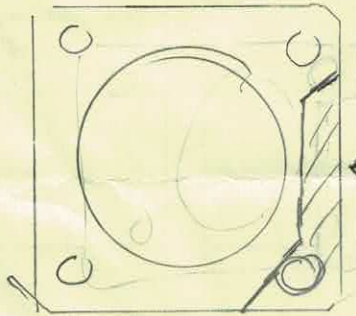
To match existing part,  
But 18mm height (not 8!)

Note indents

3 parts total

Remove 0.145 (+0.005 / -0.000)

Modify existing  
Parts

2 parts  
Modify existing part

Remove 0.070 ± 0.002 from face
